# 1722a Raw Video Format for automotive applications

July 2014

*Andy Lucas, XMOS*

Figure 13.1. Raw Video PDU format

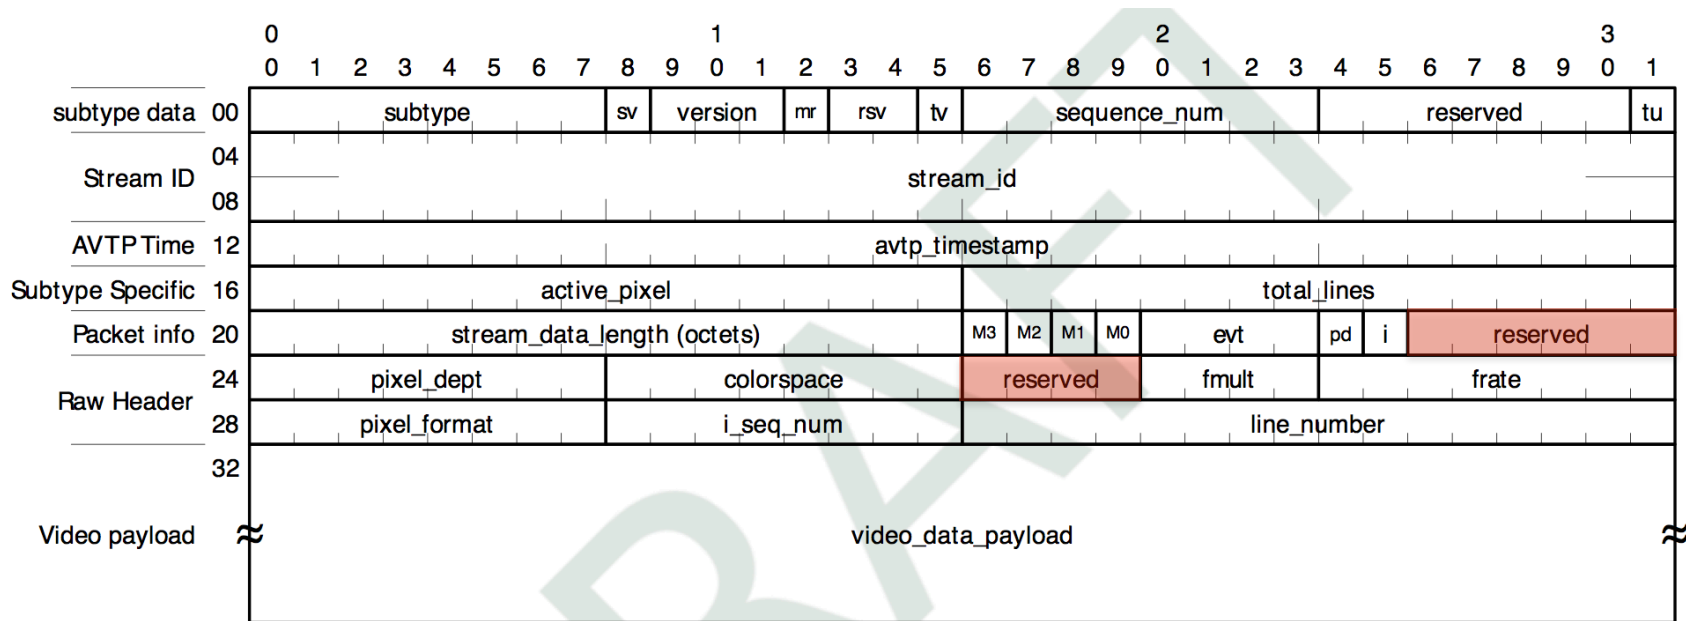
- 13.2.17 currently enforces
  - “All media samples in the AVTPDU shall be from the same line”
- For example, WQVGA or QVGA resolutions are possible @ ~100 fps but only if this constraint is relaxed and 3 lines are packed into a single AVTPDU
- For this example, the current requirement to send 3 separate AVTPDUs per interval is prohibitive using 100 Mbit due to the 74 bytes overhead per payload

- Add a field num\_lines to represent a number of lines >1 per AVTPDU
  - Using one of the currently reserved fields limits the range, but this is OK

- No change to behaviour of currently defined format when  $\text{num\_lines} = 1$
- Handling of  $\text{num\_lines} > 1$  should be optional
  - Let AVnu and others define market specific requirements for professional video, automotive etc.
- To simplify things, suggest enforcing that the intra-line sequence number  $i\_seq\_num$  (13.2.16) is 0 when  $\text{num\_lines} > 1$
- In other words, lines cannot be split across multiple AVTPDUs when the number of lines per PDU  $> 1$
- Also enforce that lines from different frames cannot be packed into the same AVTPDU
